TO: Mercedes-Benz Dealer Principals, General Managers, Sales Managers, Service Managers, Parts Managers	FROM: Gregory Gunther, Department Manager, Vehicle Compliance and Analysis, Engineering Services
RE: <b>Recall Campaign Launch Notification</b> <b>Check Ground Connection of Front Passenger Airbag MY21 247 (GLA-Class)</b>	Date: March 20, 2021

Campaign No. 2021020037, March 2021

SUBJECT: **Model GLA-Class vehicles (247 platform)**  
**Model Year 2021**  
**Check installation position of shield at front passenger airbag**

Figure 1

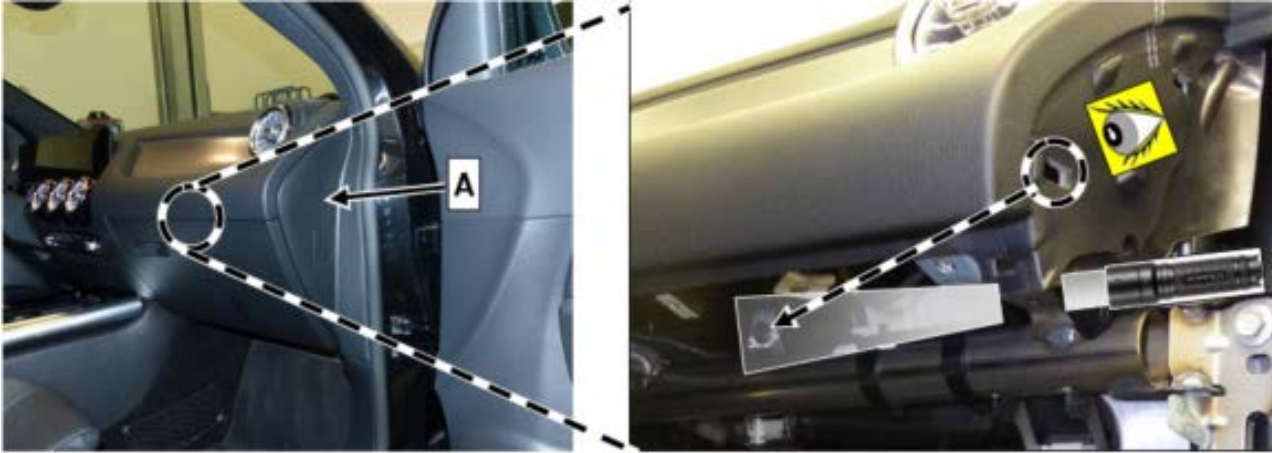
1. Remove cover (**A, figure 1**) at side at instrument panel.
2. Check installation position of shield (**B, figure 2**) at front passenger airbag.
  - i** Perform visual check through opening in instrument panel using a suitable flashlight.

Figure 2 (OK)

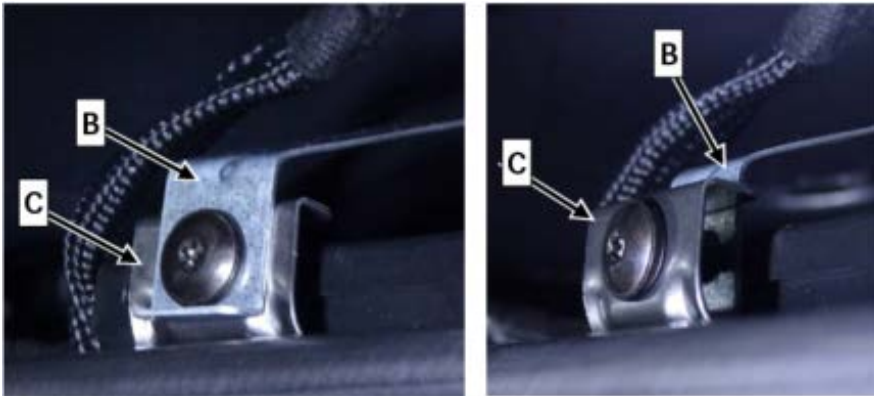
- a. Installation position of shield (B) Figure 2 OK: **End measure.**
- b. Installation position of shield (B) Figure 3 NOK: Perform **work procedure.**

1. Remove glove compartment housing.  
 For basic data, see **AR68.10-P-1400MFA**.
  2. Unscrew screw and position shield on bracket of cross-member, then screw on shield using screw.  
 Screw to crossmember **3.5 Nm**.
  3. Assemble in reverse order.
-
